19-1 - (Entire Code): Accept
SUBMITTER: Technical Correlating Committee National Electrical Code
COMMENT ON PROPOSAL NO: 19-1
RECOMMENDATION: The Technical Correlating Committee directs that the term "luminaire" be accepted as shown by the panel, but be followed by the existing term in parenthesis on all Proposals except those amended by Panel Action Text. This action is intended to provide consistency throughout the code. In addition, the Technical Correlating Committee directs the panel to clarify their action relative to the last line of the Panel Action. This action will be considered by the Panel as a Public Comment.
SUBSTANTIATION: This is a direction from the National Electrical Code Technical Correlating Committee in accordance with 3-4.2 and 3-4.3 of the Regulations Governing Committee Projects.
PANEL ACTION: Accept.
 Revise 604-6(a)(2) Exception No. 1 to (1) and (2) in both locations as follows:

1-1 - (Entire Code): Reject
SUBMITTER: Dann Strube, Lanesville, IN
COMMENT ON PROPOSAL NO: 1-1
RECOMMENDATION: The proposal should have been accepted in principle as follows:
 Leave the terms fixture, lighting fixture, etc. as they are and add (luminaire) after those terms.
SUBST

Figure 505-9(b)(1) ~~505-10(b)(1)~~

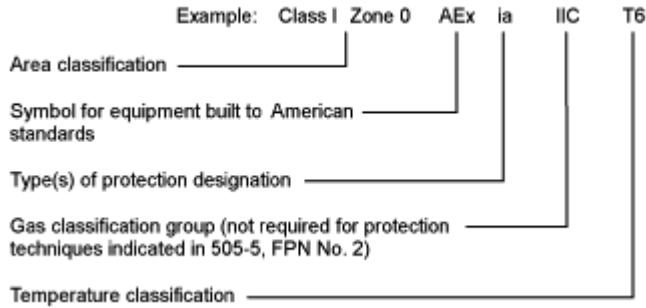
[FIX THIS REFERENCE ERROR IN FIGURE 505-9: "...indicated in 505-5, FPN

No. 2)" should read "...indicated in 505-6, FPN No.2)"]

The Technical Correlating Committee directs that "Figure 505-9(b)(1)" be changed to "Figure 505-9(c)(2)".

The Technical Correlating Committee directs that "Figure 505-9(b)(1)" be changed to "Figure 505-9(c)(2)" and the reference in the 4th line of the Figure be changed from "505-5, FPN No.2" to "505-6, FPN No. 2".

Figure 505-9(b)(1) [505-10(b)(1)]

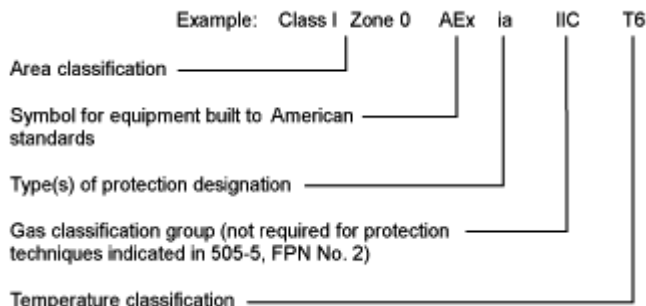
- 1) The figure now marked "Figure 505-9(b)(1)" is no longer associated with paragraph 505-9(b)(1). Change the figure to "Figure 505-9(c)(2)" to indicate its proper association.

505-9(c)(2) FPN: Change, "...shown in Figure 505-9(b)(1)" to "... shown in Figure 505-9(c)(2)."

16- 90 - (Figure 725-61): Accept

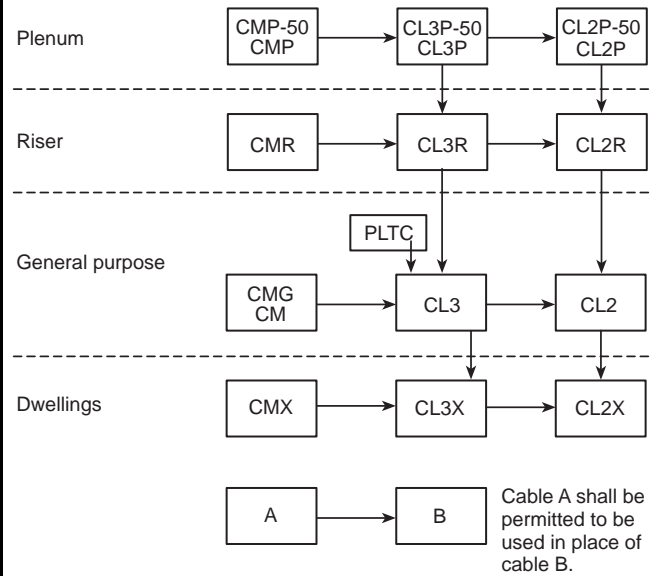
RECOMMENDATION: Revise Figure 725-61 as shown:

16- 239 - (Figure 770-53): Accept
Note: "See Technical Correlating Committee action on Comment 16-98."
SUBMITTER: Stanley Kaufman, Lucent Technologies
COMMENT ON PROPOSAL NO: 16-177
RECOMMENDATION: Revise Figure 770-53 as shown:

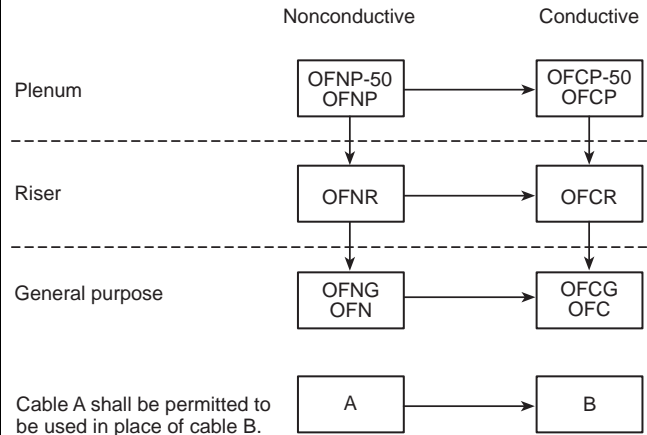
SUBSTANTIATION: This comment revises Figure 770-53 to be consistent with Table 770-53.
PANEL ACTION: Accept.
NUMBER OF PANEL MEMBERS ELIGIBLE TO VOTE: 21
VOTE ON PANEL ACTION:
 AFFIRMATIVE: 20
 ABSTENTION: 1
EXPLANATION OF ABSTENTION:
 CAUDILL: The Society of the Plastics Industries could not reach a consensus position on this issue.

16- 310 - (Figure 800-53): Accept

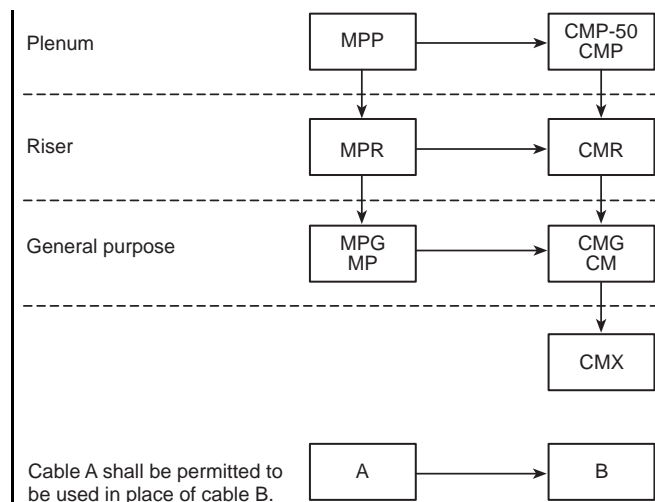
RECOMMENDATION: Revise Figure 800-53 as shown:

SUBSTANTIATION: This comment revises Figure 800-53 to be consistent with Table 800-53.

16- 365 - (Figure 820-53): Accept

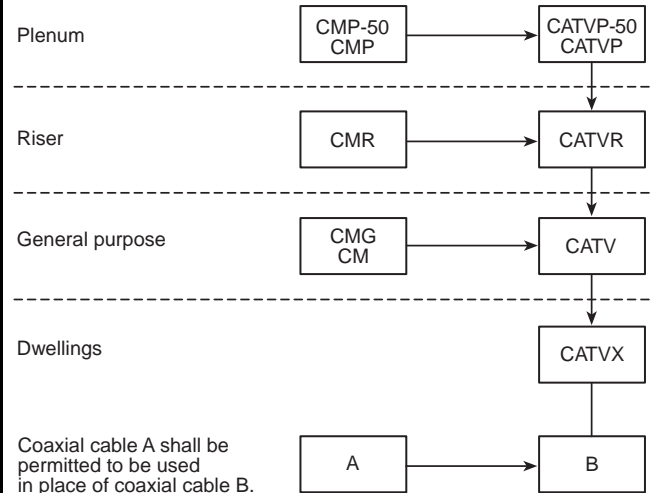
RECOMMENDATION: Revise Figure 820-53 as shown:

SUBSTANTIATION: This comment adds Type CMP 50 to the cable substitution table and adds a consistent revision of the cable substitution figure. Note that the inclusion of Type CMX in Figure 820-53 in the 1999 NEC is an error; Table 820-53 does not permit CMX coaxial cable to substitute for Type CATVX.
